## *City of El Paso – City Plan Commission Staff Report*

**Case No:** SUSU12-00043 San Clemente Unit Two Replat “A”  
**Application Type:** Resubdivision Combination  
**CPC Hearing Date:** May 17, 2012  
**Staff Planner:** Nathaniel Baker, (915) 541-4192, [bakernt@elpasotexas.gov](mailto:bakernt@elpasotexas.gov)  
**Location:** East of Stanton Street and South of Clemente Avenue  
**Acreage:** 1.61 acres  
**Rep District:** 1  
**Existing Use:** Vacant  
**Existing Zoning:** PMD (Planned Mountain Development)  
**Proposed Zoning:** PMD (Planned Mountain Development)  
**Nearest Park:** Galatzan Park  
**Nearest School:** Green Elementary (1.5 miles)  
**Park Fees Required:** Excluded  
**Impact Fee Area:** N/A  
**Property Owner:** Adrain M. Guevara and Carmen Gloria Yamal  
**Applicant:** Adrain M. Guevara and Carmen Gloria Yamal  
**Representative:** Roe Engineering L.C.

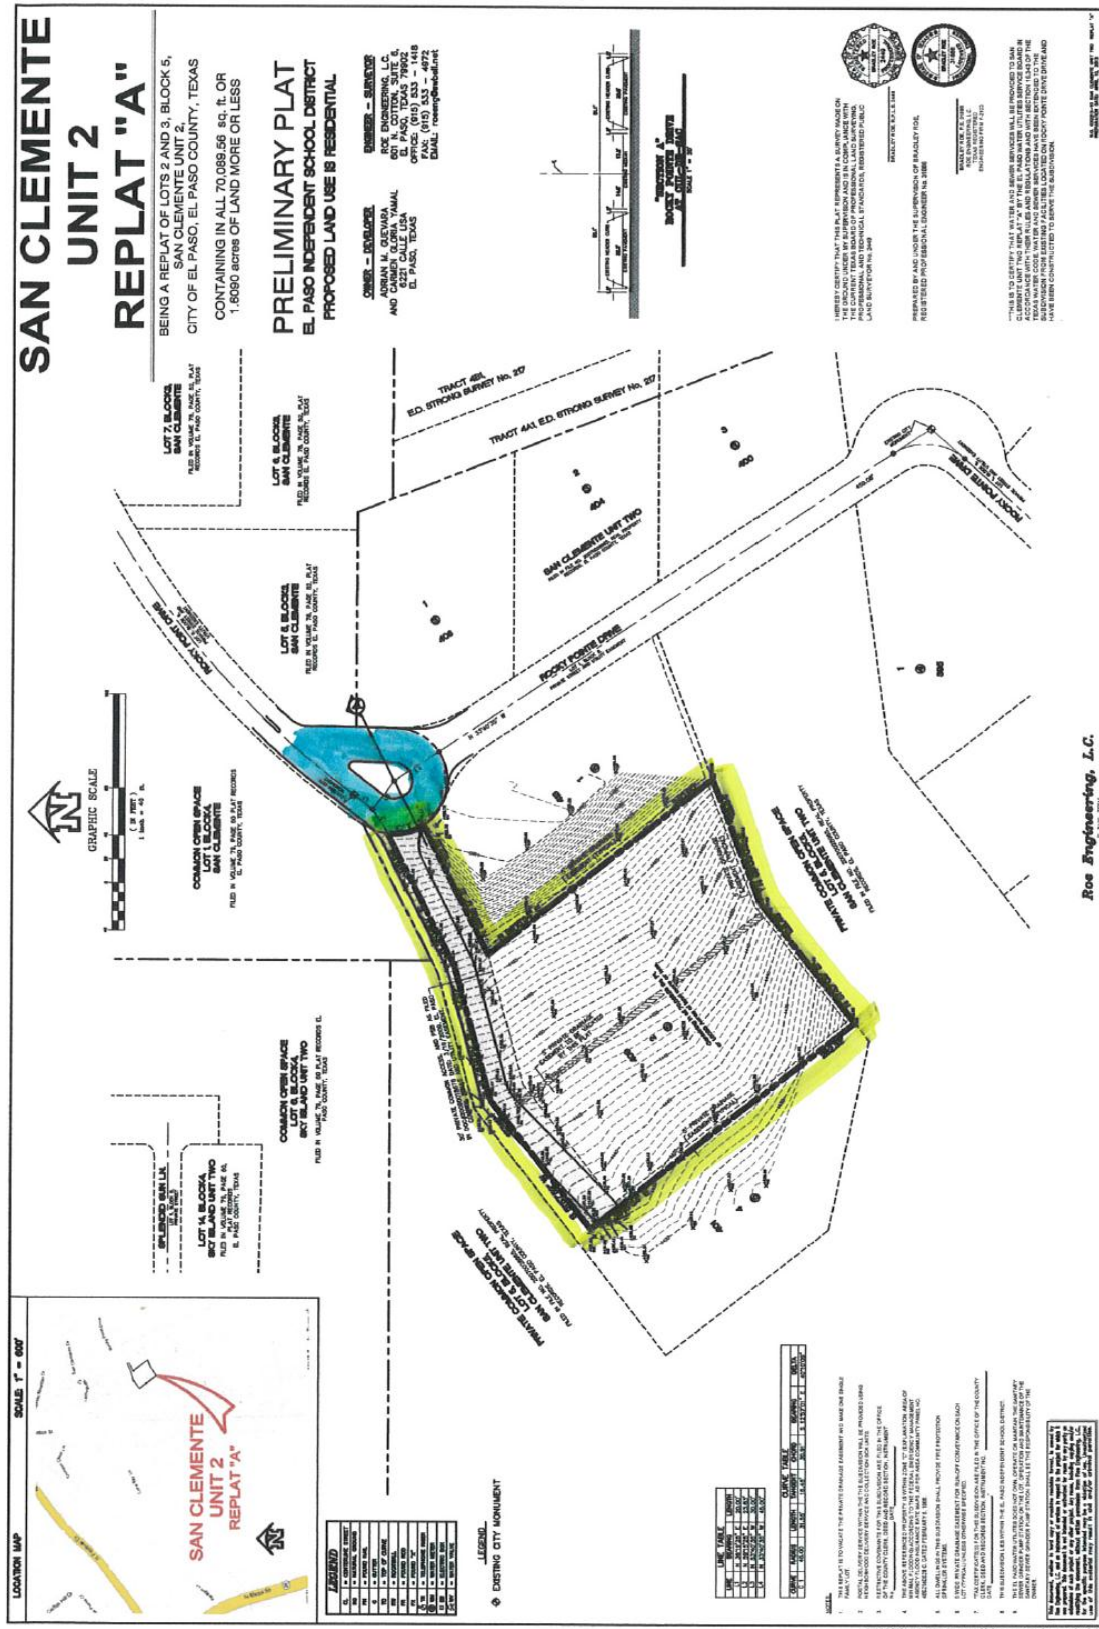
1. There is an existing 30-foot wide PSB easement along the 30-foot wide access easement. This easement shall be labeled “PSB easement”

2. There is an existing 6-inch diameter water main within the above mentioned 30-foot wide PSB easement. This water main is located 1.50-feet south of the northern property line.

3. EPWU records indicate one active meter connection at 409 Rocky Point Drive and one vacant meter connection at 405 Rocky Point Drive. The Owner/Developer is to inform EPWU in writing which water meter connection is going to remain. The Owner/Developer is responsible for all costs associated with the disconnection of the selected water service at the main.

4. There is an existing 8-inch diameter sanitary sewer main along Rocky Point Drive.

5. The grading of the property does not allow sanitary sewer service by conventional gravity means. The subdivision will be served by private grinder pump stations at the Lot and a low pressure sanitary sewer system (private force main).
